**PLANNING COMMISSION MEETING
VIRTUAL MEETING VIA WEBEX
MARCH 28, 2022
7:00 PM**

Public hearing to consider a request for a site plan approval and a variance for a daycare, take-out restaurant, and event space at 6436 Penn Avenue South.

Public hearing to consider a request for an amended Planned Unit Development, Final Development Plan and Conditional Use Permit to allow a micro-brewery and brewpub/taproom at 6402 Lyndale Avenue South.

Public hearing to consider a request for an amended Planned Unit Development, Final Development Plan and Conditional Use Permit to allow a micro-brewery and brewpub/taproom at 6402 Lyndale Avenue South.

SITE PLAN

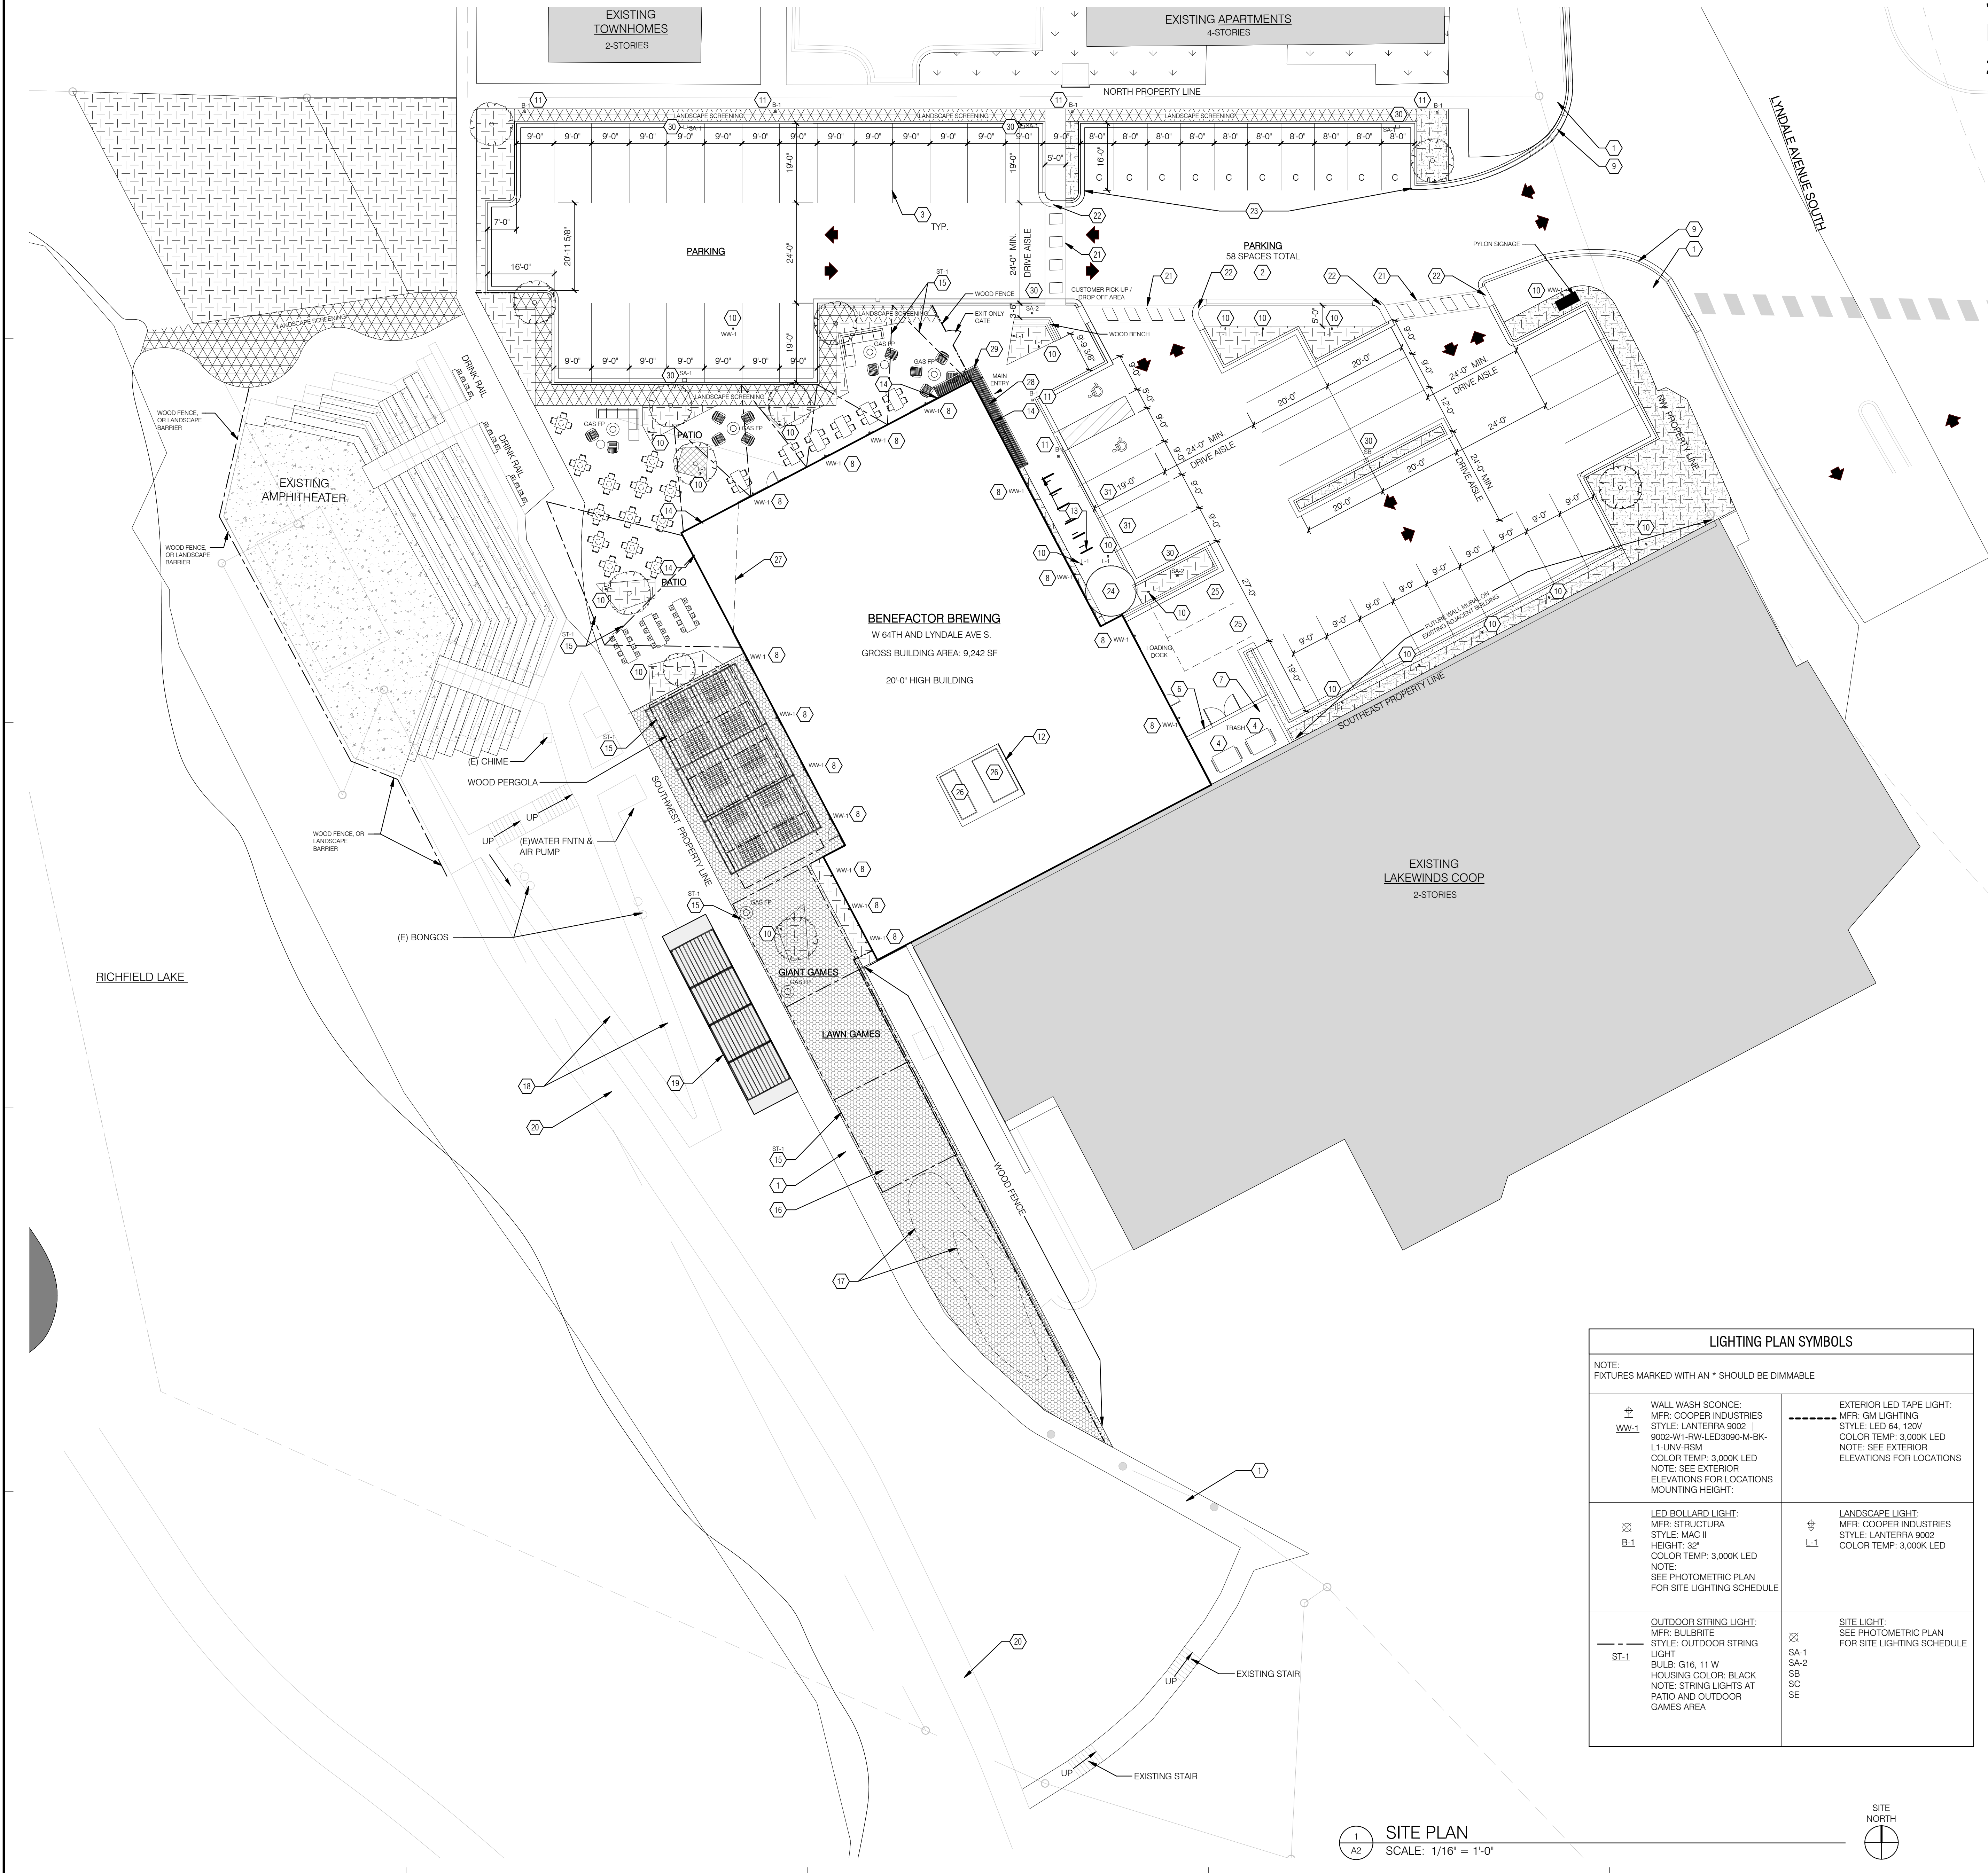
- Front Setback and building placement. The existing planned unit development depicted the building on this site up near Lyndale Avenue reflective of the maximum front yard setback for commercial buildings in the Mixed Use District of 15 feet. The proposed building would be setback approximately 136 feet from the front property line. The intention of the original PUD is to establish a street presence and pedestrian scale by creating building mass along primary Lyndale Avenue. The proposal seeks to maintain that street-level interest by way of a pedestrian connection lined with landscaping from Lyndale Avenue to the building's main entrance. Additionally, a decorative grain silo and use of storefront windows contribute to the proposed building's street presence furthering the intent of this requirement.

- Parking lot islands. Five percent of the area encompassing the parking lot is to consist of landscape islands, each being 10 feet by 10 feet and 180 square feet. Landscaping is provided both within islands and around the perimeter of the parking area. The intent of this provision is to provide a well landscaped and attractive parking area. The proposed landscaping plan achieves this intent.

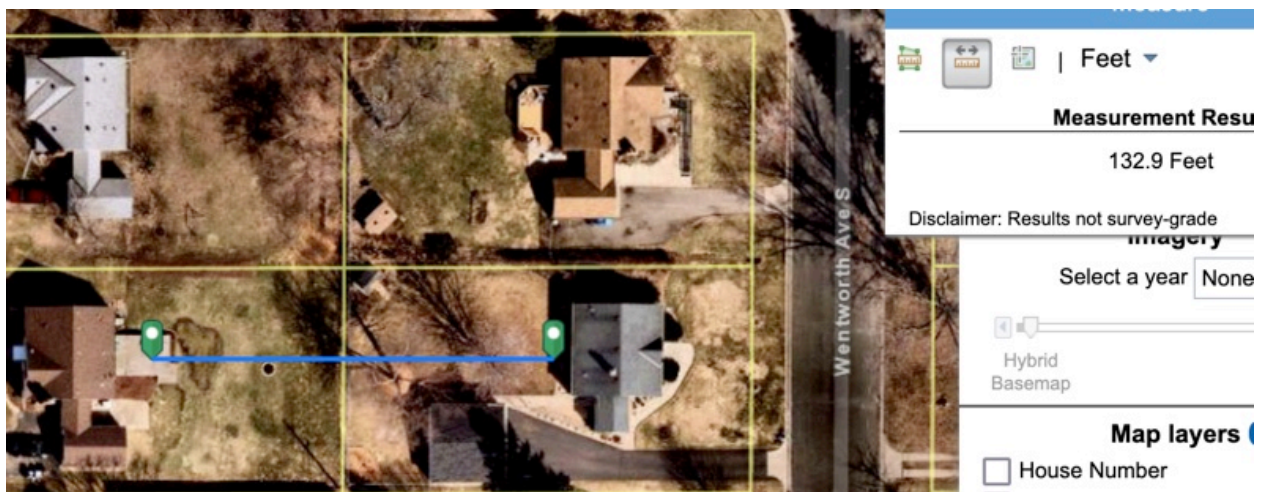
My clients are deeply concerned about the impact that the proposed brewpub will have on their quality of life, and in particular they and the other residents object to the proposed outdoor seating area and the noise it will generate. That outdoor drinking and eating area next to the

brewery building begins just 100 feet from the decks on the nearest condo building, where my clients reside, which is shown in this aerial photograph:

This is less than the distance between two typical Richfield houses on either side of an alley, shown here as approximately 130 feet:
